## **EXHIBIT A-6**

### **ADDENDA**

**NORTHERN KENTUCKY WATER DISTRICT  
TAYLOR MILL TREATMENT PLANT  
TMTP UPGRADES & IMPROVEMENTS  
Project No. WX21117018**

**ADDENDUM NO. 1**

**ATTACHMENT 2-C**  
**REVISED SHEET P3.0**

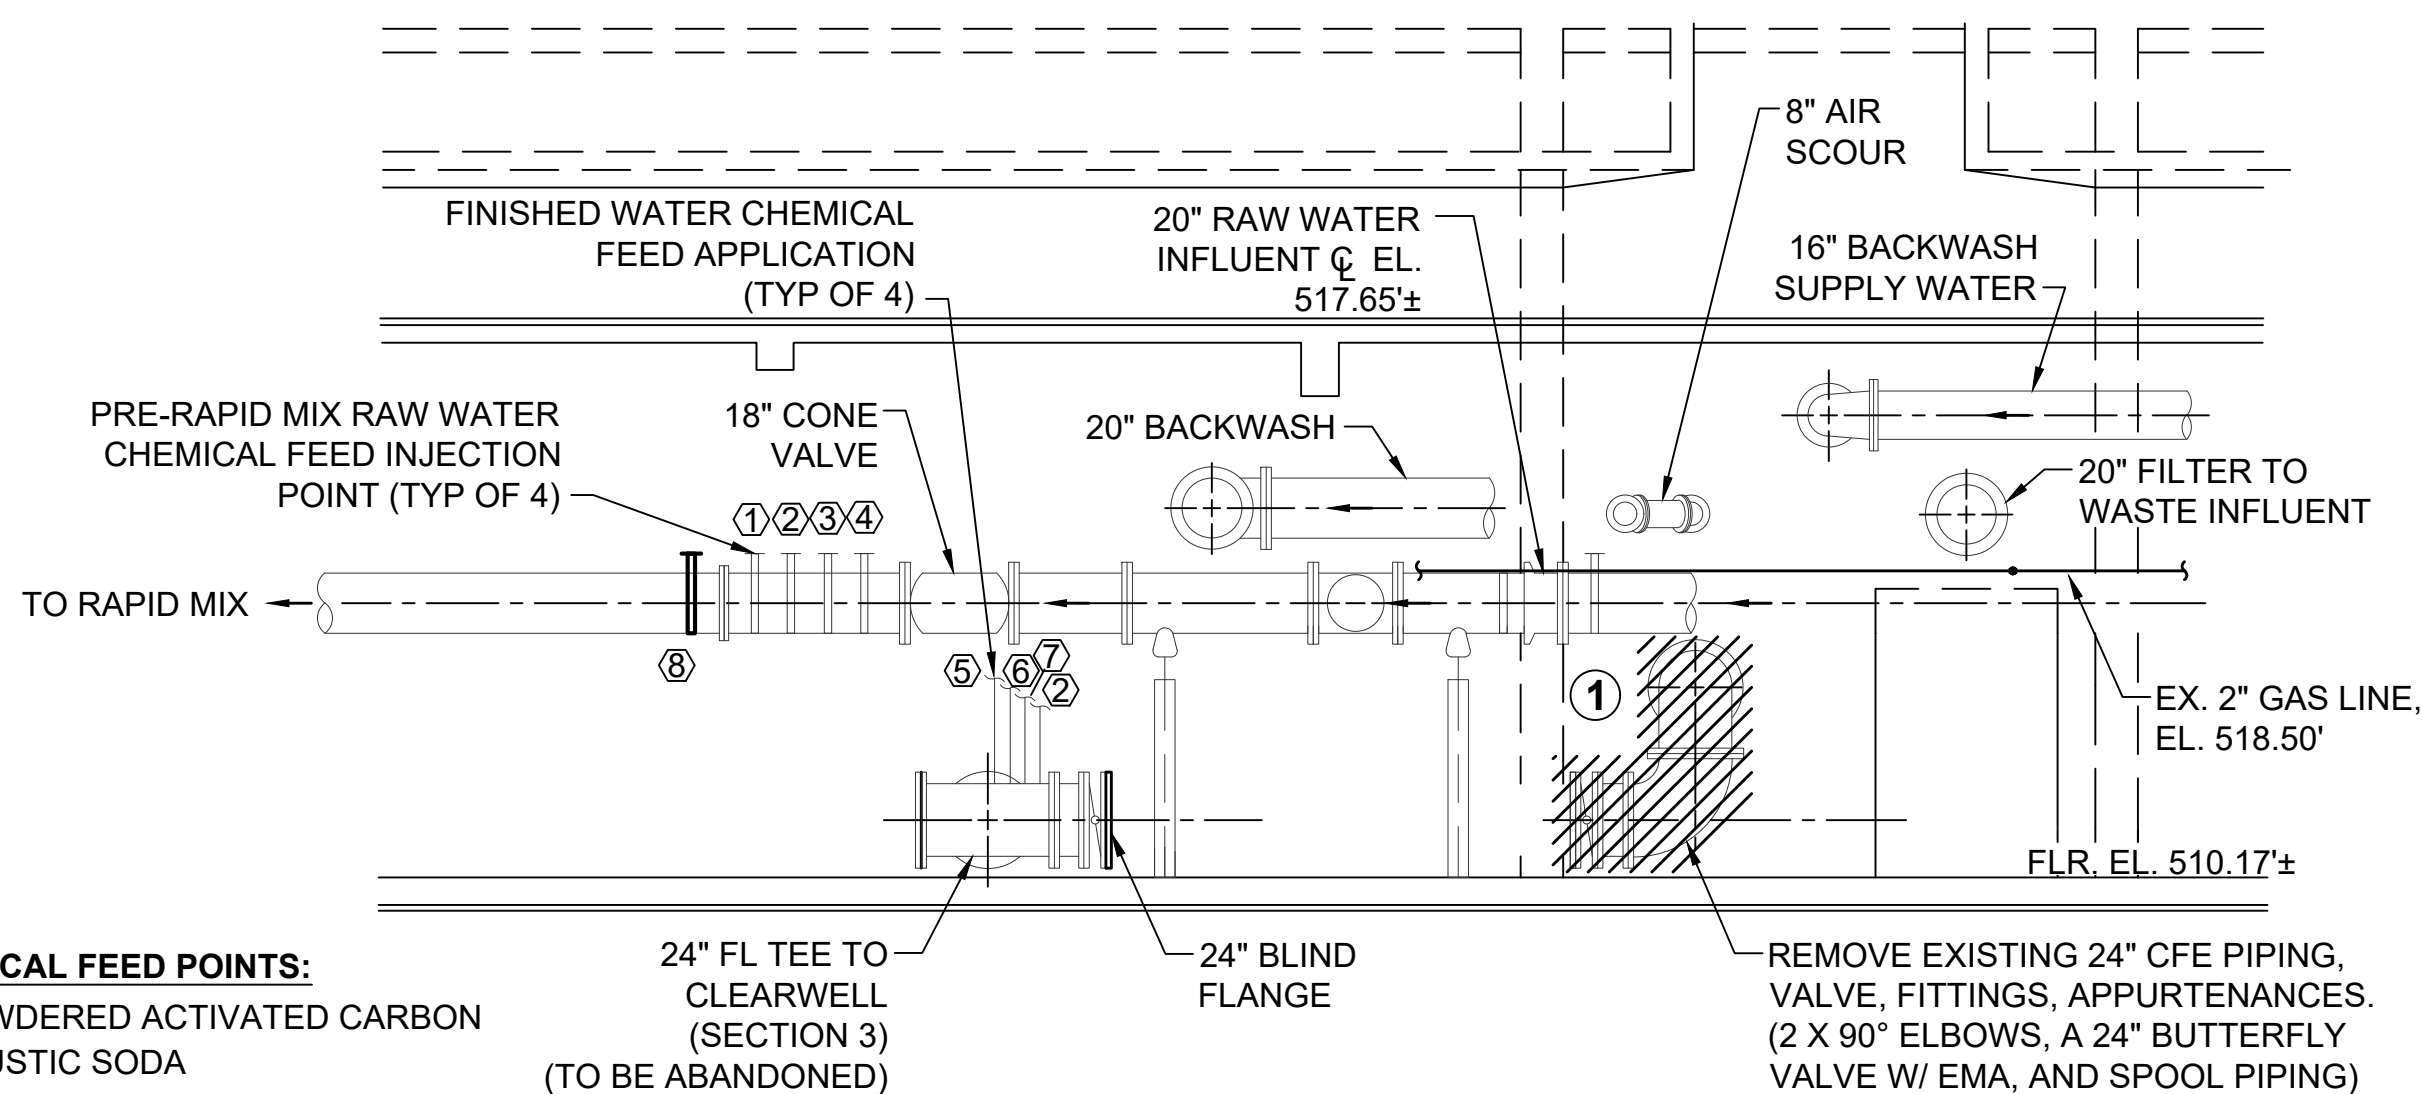
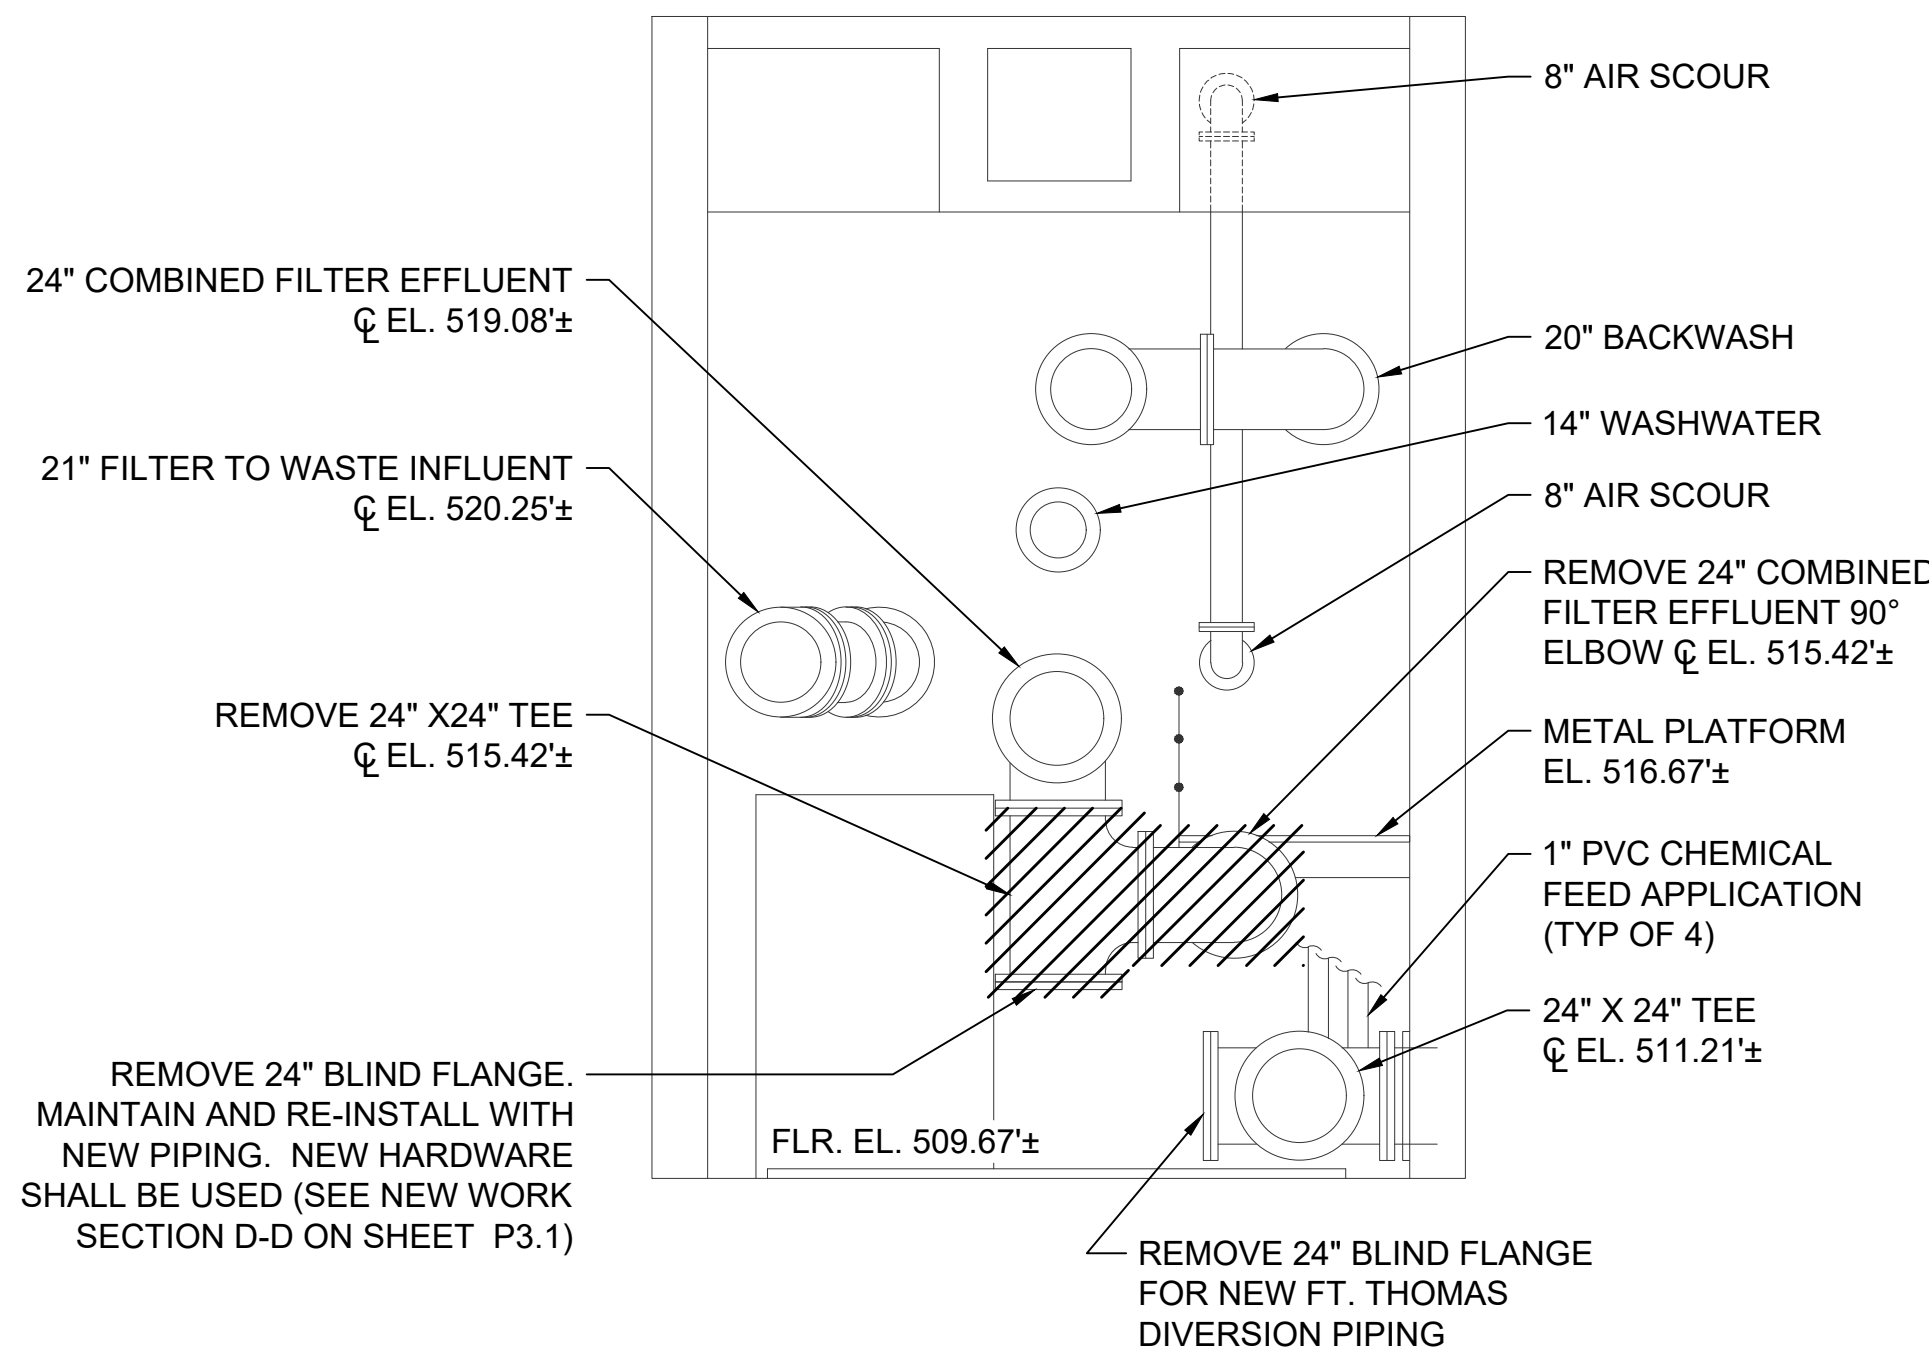
- Item 8. Specifications 233113, Section 3.10/E/7
- Delete '7' in its entirety
- Item 9. Sheet P3.0, Add Alternative Bid Item: Ft. Thomas Diversion Piping Plan & Sections

- Delete in its entirety
- Insert new Sheet P3.0, Add Alternative Bid Item: Ft. Thomas Diversion Piping Plan & Sections, provided in Attachment 2-C.
- Item 10. Sheet P3.1, Add Alternative Bid Item: Ft. Thomas Diversion Piping Sections
